Product/Process Change Notice (PCN)

PCN #: PCN_absSECF_20170313

Product Affected: WE-SECF series

Before change

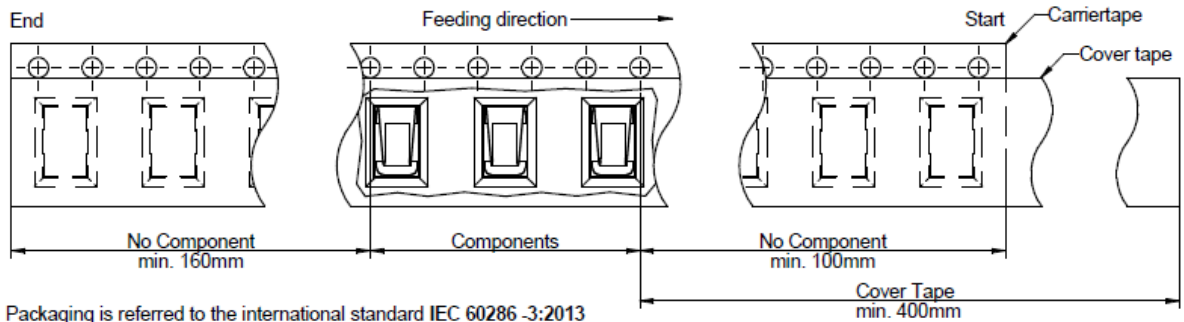
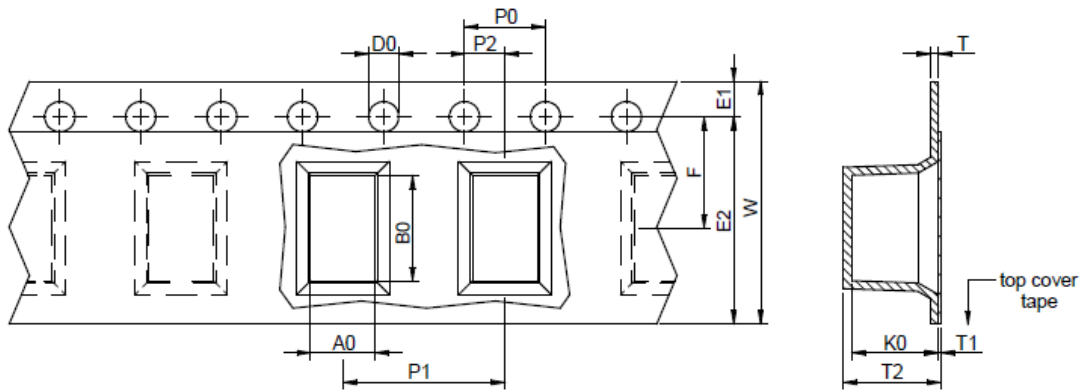
Packaging is referred to the international standard IEC 60286 -3:2013

A0	B0	W	P1	T	T1	T2	D0	E1	E2	F	P0	P2	Tape	VPE / packaging unit	
tolerance	typ.	typ.	±0,3	±0,1	±0,1	max.	typ.	+0,1/-0,0	±0,1	min.	±0,05	±0,1	±0,05		pcs.	
size	1562	2,70	17,15	16	8	0,35	0,1	6,8	1,5	1,75	14,25	7,5	4	2	Polystyrene	1200

After change

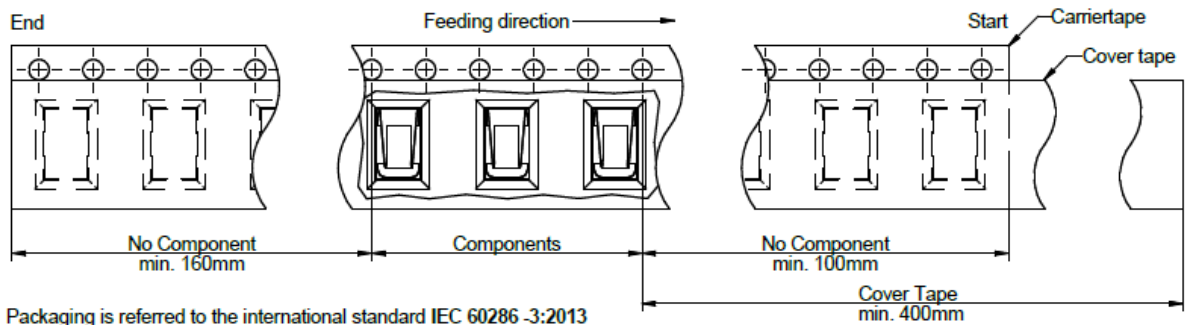
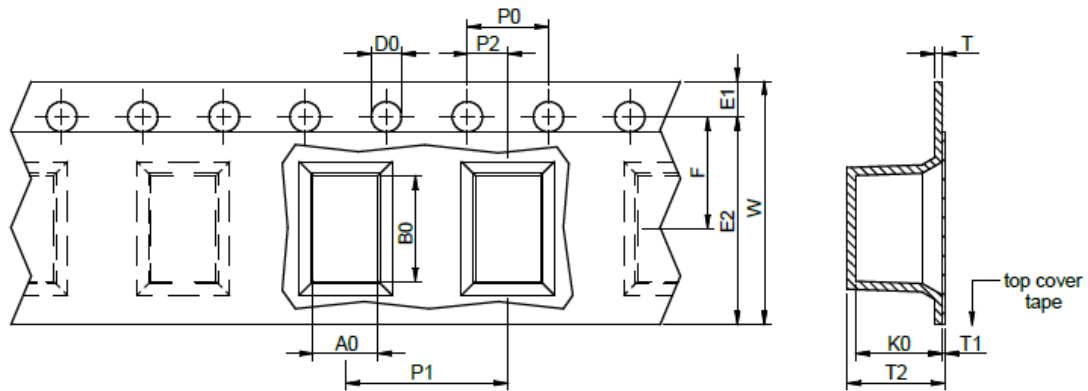
In order to enhance the product reliability, Würth Elektronik will change the packaging specifications of the product.

Packaging is referred to the international standard IEC 60286 -3:2013

A0	B0	W	P1	T	T1	T2	K0	D0	E1	E2	F	P0	P2	Tape	VPE/ packaging unit	
tolerance	typ.	typ.	±0.3	±0.1	±0.1	max.	typ.	±0.1	+0.1/ -0.0	±0.1	min.	±0.05	±0.1	±0.05		pcs.	
size	1562	2.70	7.25	16.00	8.00	0.35	0.10	6.80	6.55	1.50	1.75	14.25	7.50	4.00	2.00	Polystyrene	1200
